CLARK
BARNES

MUP REVISION

323 BELLEVUE AVE E, SEATTLE, WA 98102

PROJECT #:3037110-LU

FLOOR PLANS - PARKING LEVEL

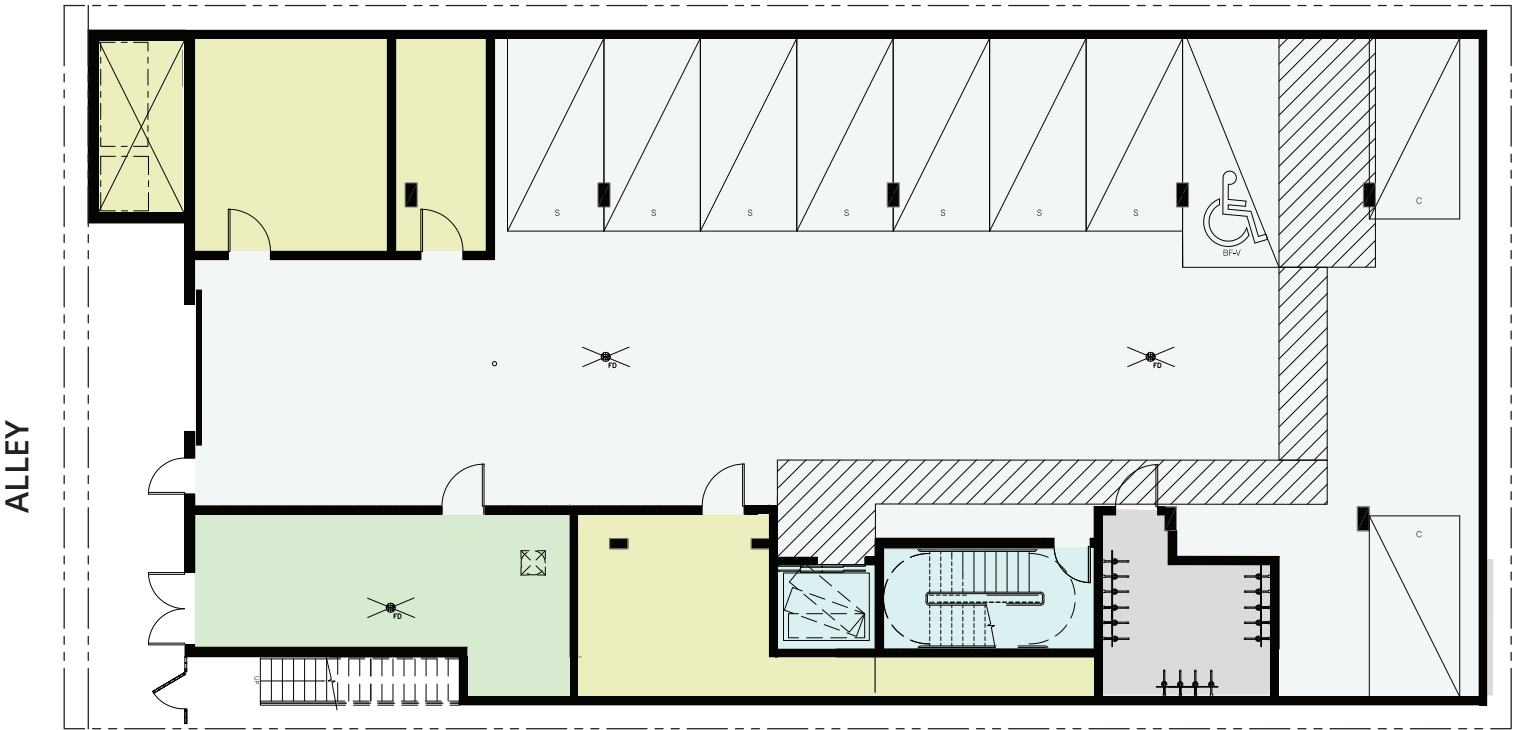
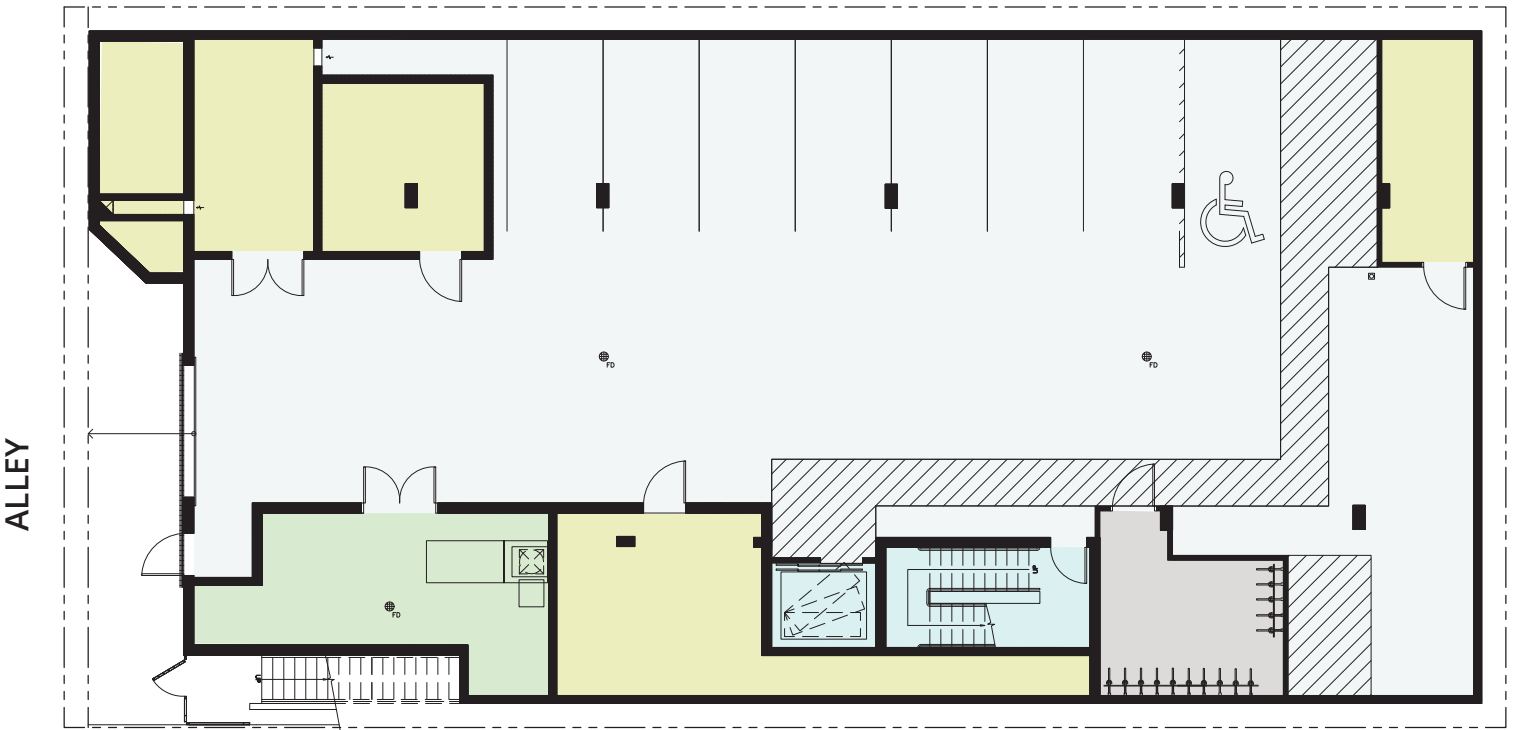
- Layout changes were made to accommodate Seattle City Light and various building utilities.
- Garbage room's exterior access door to alley was removed, streamlining the facade and reducing visible utility doors. [DC1.C.4]

FLOOR PLANS - GROUND LEVEL

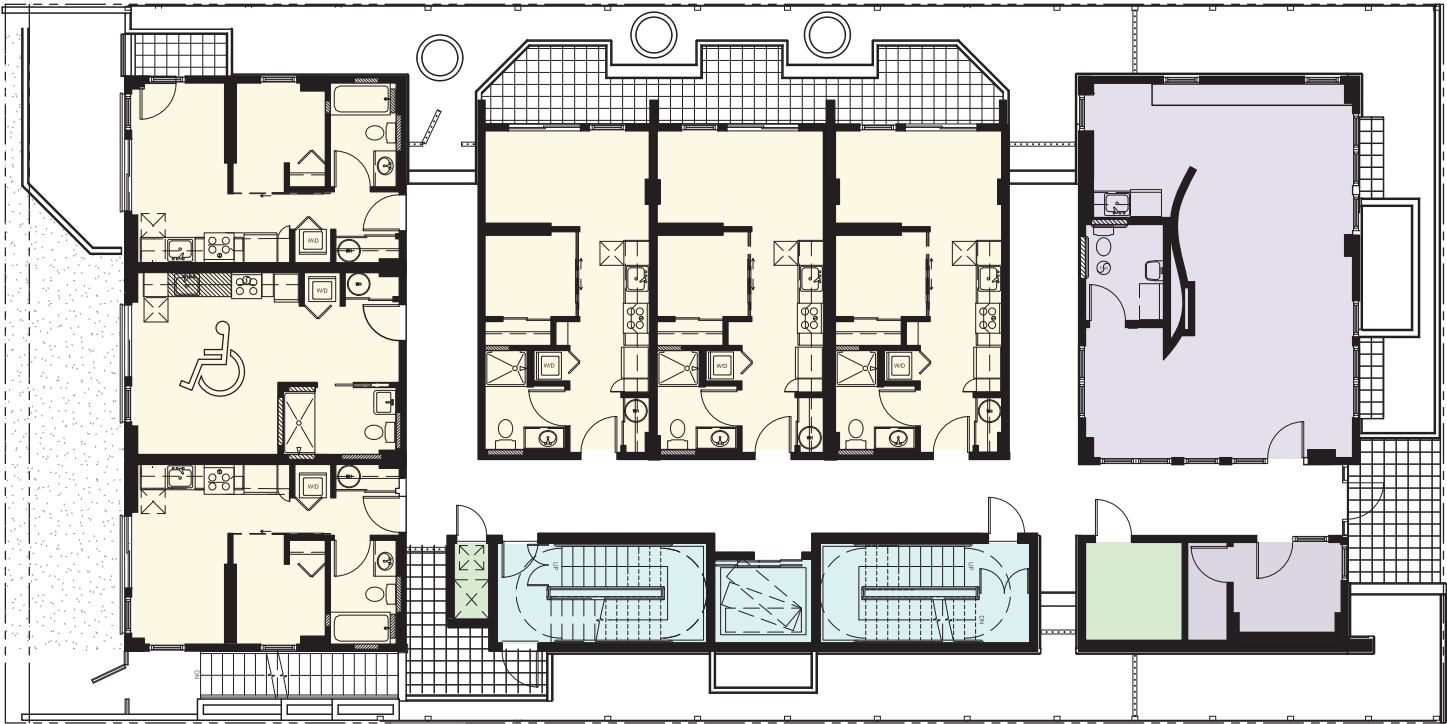
- Ramp added for ADA Accessibility while retaining direct street entry off Bellevue Ave E. [PL2.1]
- Enhanced landscaping along sidewalk. [PL3A.2 & DC4.4]
- Southern facade jog straightened out to simplify massing and provide a clear, 3-part facade punctuated by the visually open corridor endings. [CS3.A.2]
- Metal gates along north breezeways were replaced with glass to have visually open corridors at the ground while providing security within the building. [PL3.B.1]

FLOOR PLANS - LEVEL 2 - 5

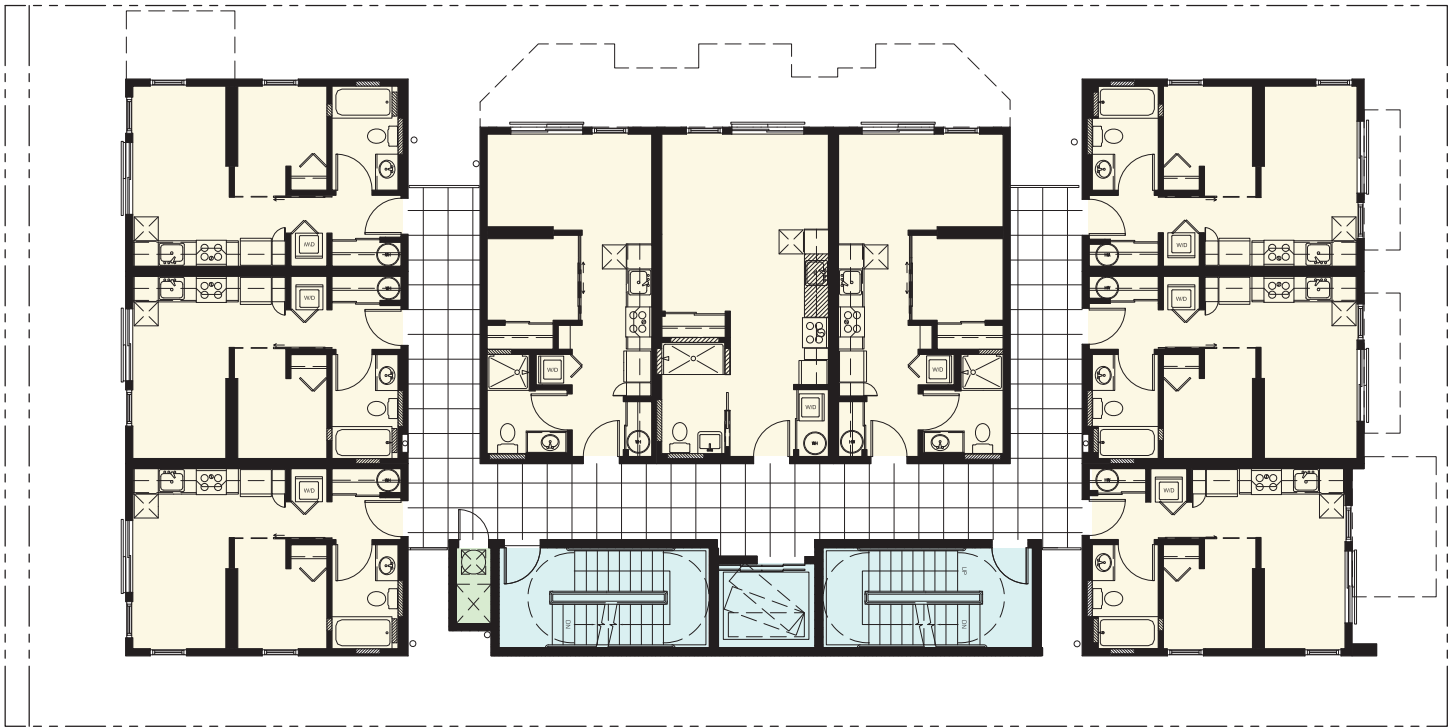
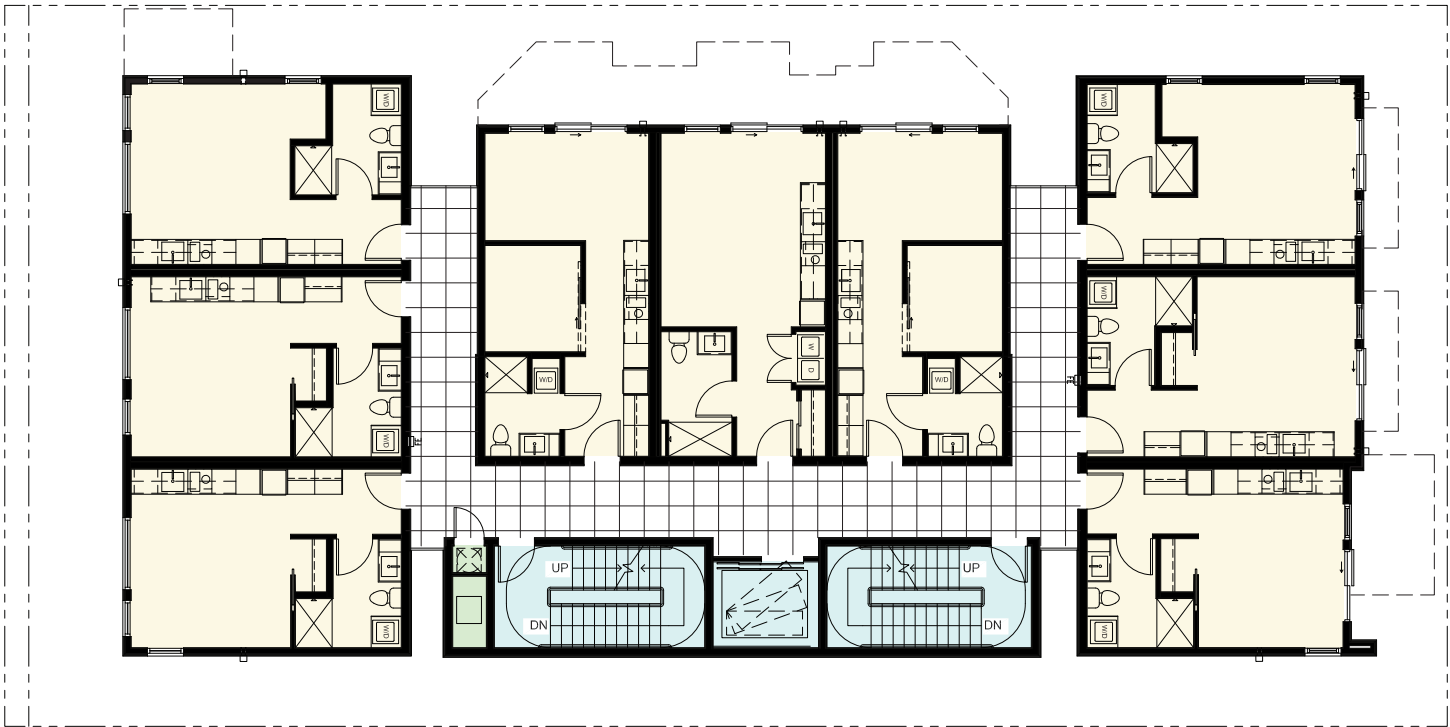
- Southern facade jog straightened out to simplify massing and provide a clear, 3-part facade punctuated by the visually open corridor endings.
- [CS3.A.2]

FLOOR PLANS - LEVEL 6

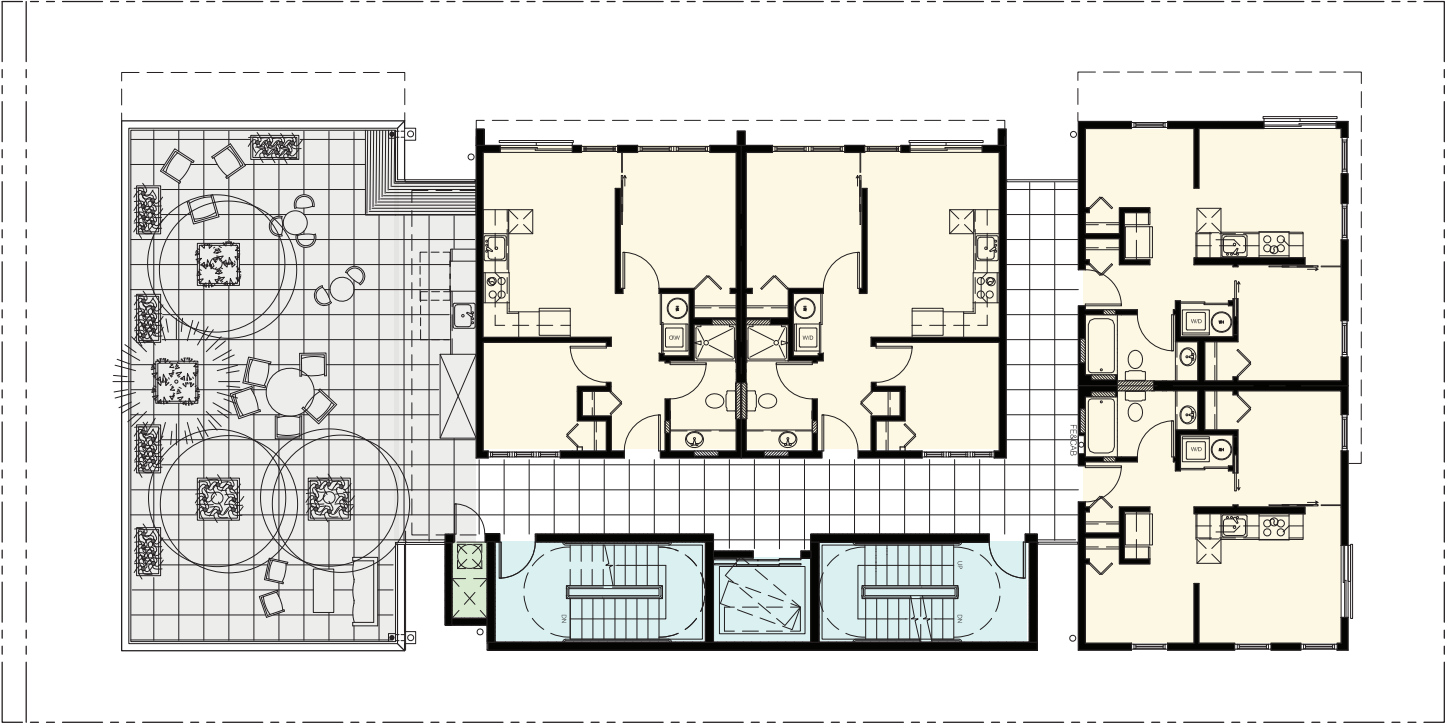
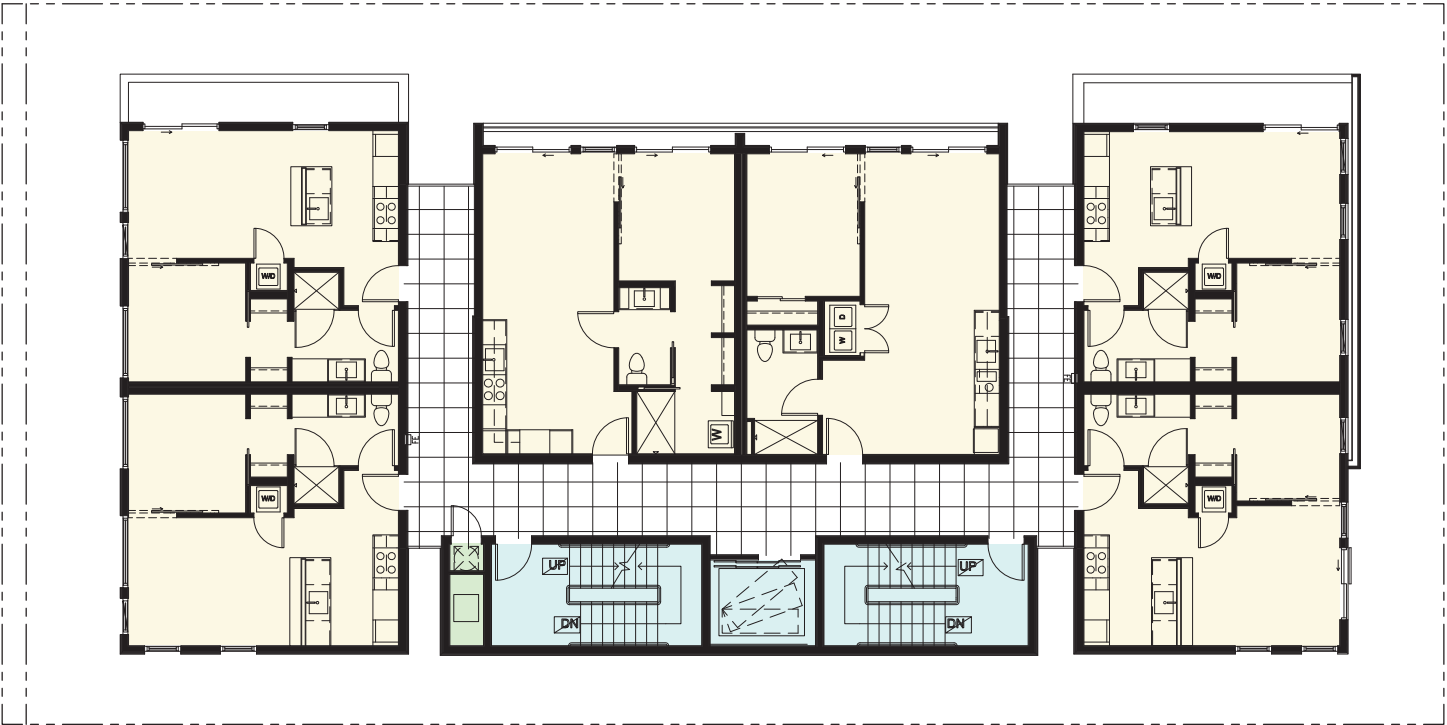
- Two units were added to the 6th floor (west end), bringing the project into better alignment with current MHA zoning. **[Note: under current zoning, an entire 7th floor and 20' of height could be added to the project]** [CS2.D]
- Roof amenity area was moved up one level, consistent with location recommended by DRB 'the amenity space at this location shares the best view with all the future tenants.' [PL1.C]
- Southern facade jog straightened out to simplify massing and provide a clear, 3-part facade punctuated by the visually open corridor endings. [CS3.A.2]

FLOOR PLANS - ROOF LEVEL

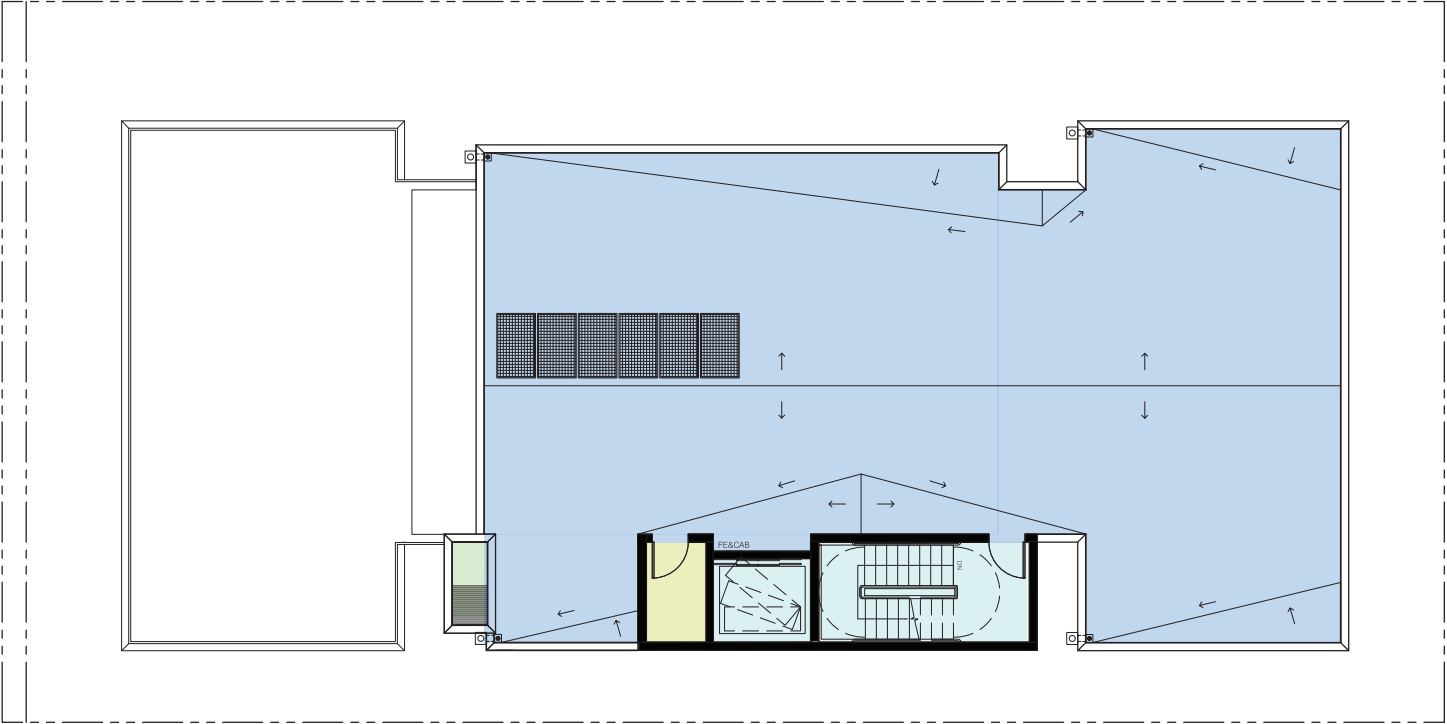
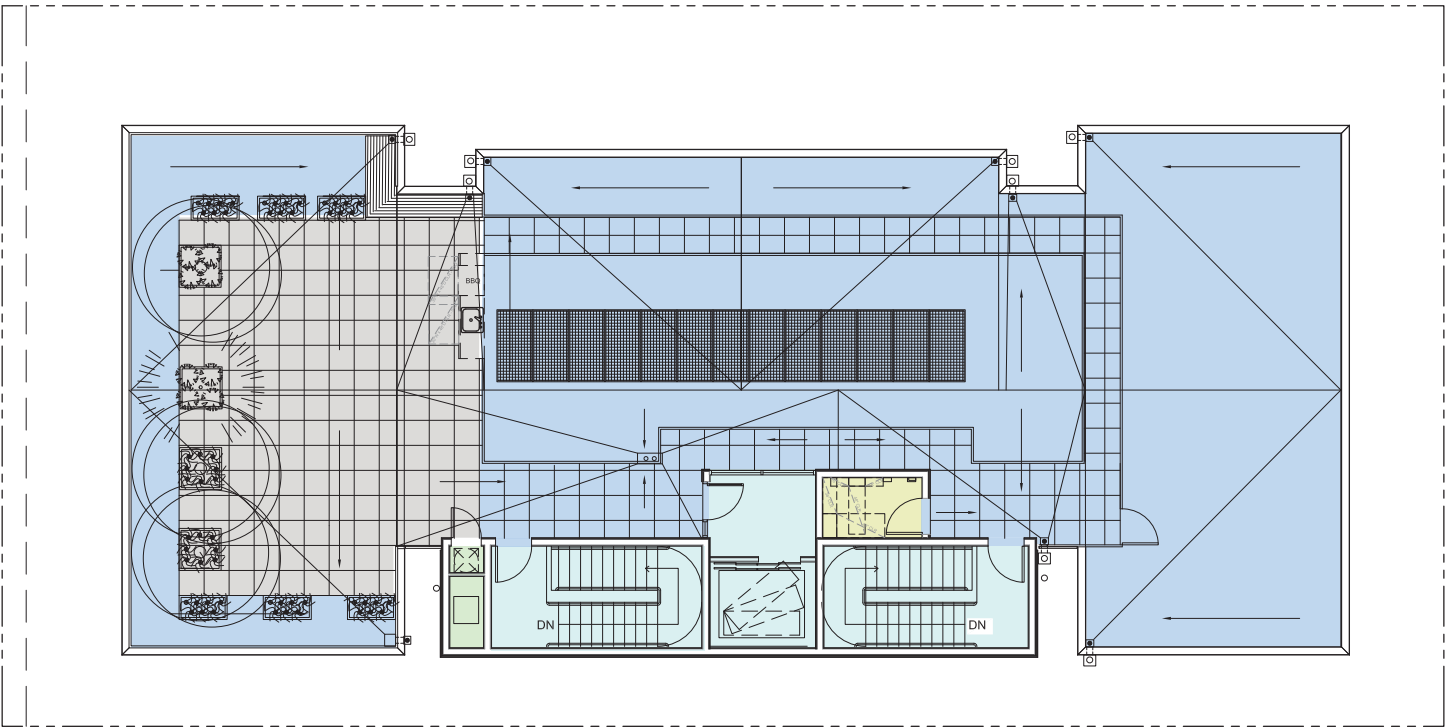
- Roof amenity area was moved up one level, consistent with location recommended by DRB 'the amenity space at this location shares the best view with all the future tenants.' [PL1.C]
- Roof penthouse increased to provide roof amenity access and accessibility for all residence. [PL2.1]
